Amendment #1

Issue Date: September 2, 2022
Project: RFP EVMSCAMERAEMERGENCY23-101

D. Hague Club Apartments (HCA)

HAGUE CLUB APARTMENTS

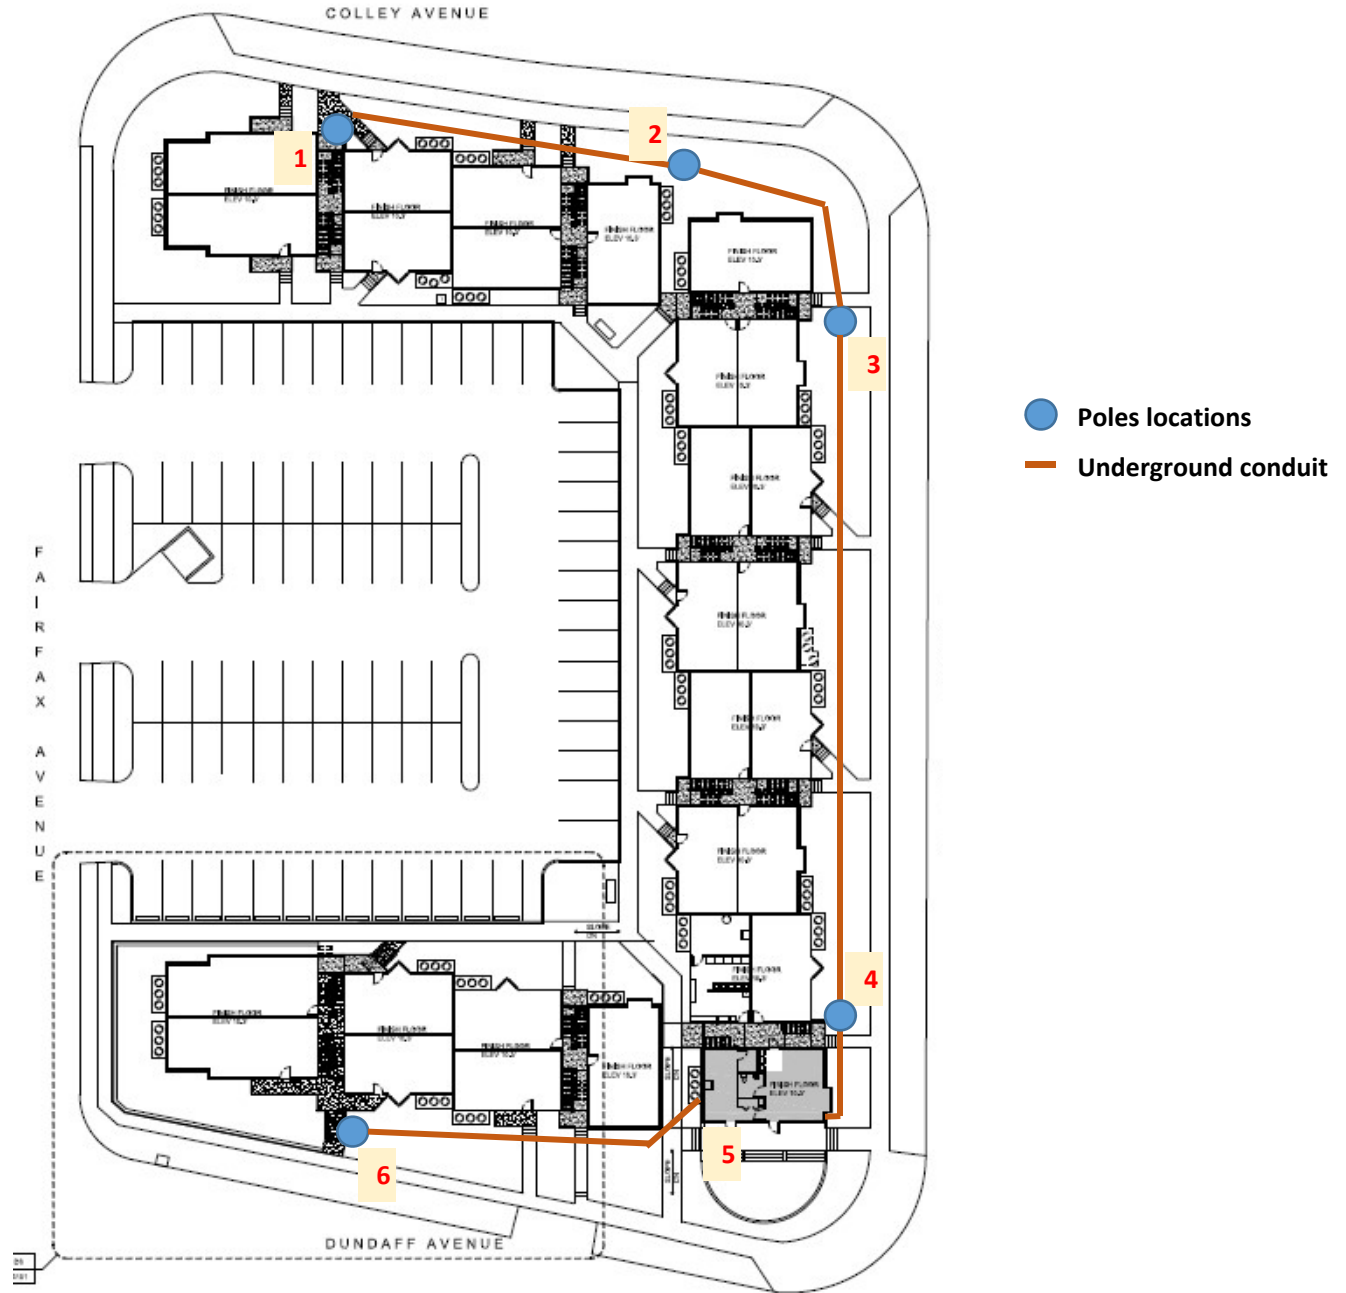
The contractor shall provide, install and integrate eight new IP cameras and two Aiphone call boxes, using the available internet connection and networking switch, and following the provided layout.

- *Two cameras and two call boxes attached to the parking lot light poles, will be wirelessly connected with the HCA main office and powered from the poles. The contractor shall provide transformers to deliver 24V DC power to these cameras and call boxes.*

- *Six cameras will be installed on the exterior sides of the building and POE with CAT6 cabling to HCA main office. The contractor shall provide estimates for 2 installation options as follows:*

- *Cameras mounted on poles*
The contractor shall provide and install 5 poles (10 feet tall) on the sides of the complex to be used for cameras. The poles shall be connected with the main (leasing) office with underground conduits (2 inch) for CAT6 cabling. Camera #5 will be attached to the corner of the main office (not on pole).

- *Cameras mounted on the walls*
The contractor shall install the cameras on the walls using CAT6 cabling under the wall vinyl siding and underground conduits (2 inch) to connect the cameras with HCA main office. Camera #5 attached to the corner of the main office doesn't need underground conduit.

2. Attachment I – Floor Plans pertaining to Hague Club Apartments have been updated to reflect the revised SOW and are enclosed herein.

Cameras locations for walls mounting

For poles mounting, poles should be installed at the locations on the lawn
